Subject: Mariposa Energy Project (09-AFC-03)
Supplement A - Data Adequacy Responses

APPLICATION FOR CERTIFICATION
SUPPLEMENT A
RESPONSE TO DATA ADEQUACY REVIEW

FOR THE
Mariposa Energy Project

FIGURE DA 3.0-2
ALTERNATIVE TRANSMISSION
LINE ROUTES
 MARIPOSA ENERGY PROJECT
 ALAMEDA COUNTY, CALIFORNIA

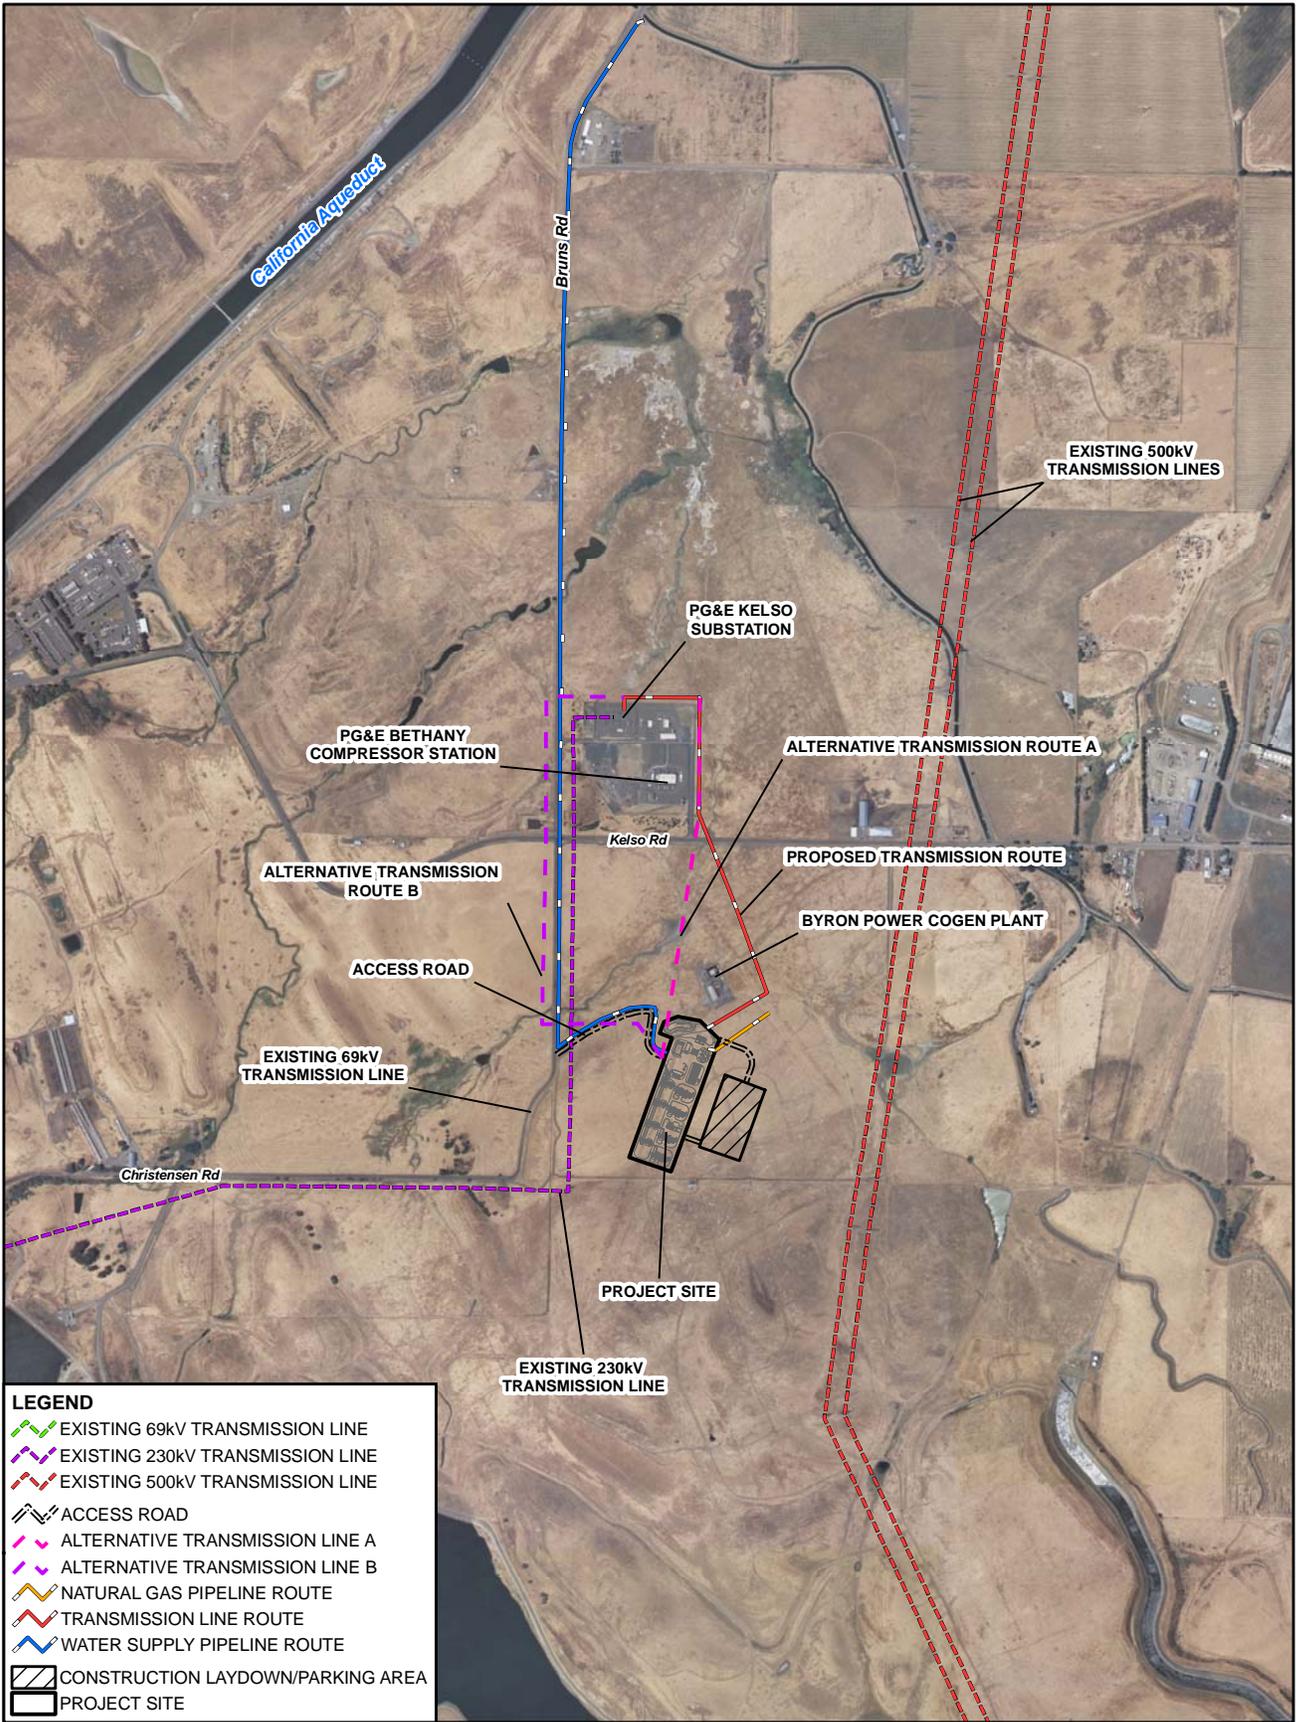
Please show alternate routes in Figure 3.2-1 and describe how the route of the proposed 230 kV generator tie line was selected by comparing with alternate routes and their environmental effects.

Response: Based on the proximity of MEP to the PG&E Kelso Substation, route alternatives for the 230-kV transmission line are limited. Mariposa Energy did consider two alternate routes as outlined below and depicted on Figure DA3.0-2.

- Proposed Route - The proposed 0.7-mile-long transmission line route for MEP interconnection to the Kelso Substation will exit the northeastern corner of the project site, heading northeast from the project site, east of the Byron Power Cogen Plant, then north crossing Kelso Road, and staying east of the PG&E Bethany Compressor Station. It will turn west just north of the Kelso Substation, then turn south to the final interconnect point at the Kelso Substation.

- Alternate Route A - The 230-kV route would exit the project site at the northwest corner, and follow a direct path north, passing to the west of the Byron Power Cogen Plant and crossing over the Cogen's interconnection transmission line. The route would head directly to the southeastern corner of the PG&E Bethany Compressor Station, where it would follow the proposed route along the eastern and northern boundaries of the Kelso Substation. This route would be the most direct, with a total distance of approximately 0.6 miles.
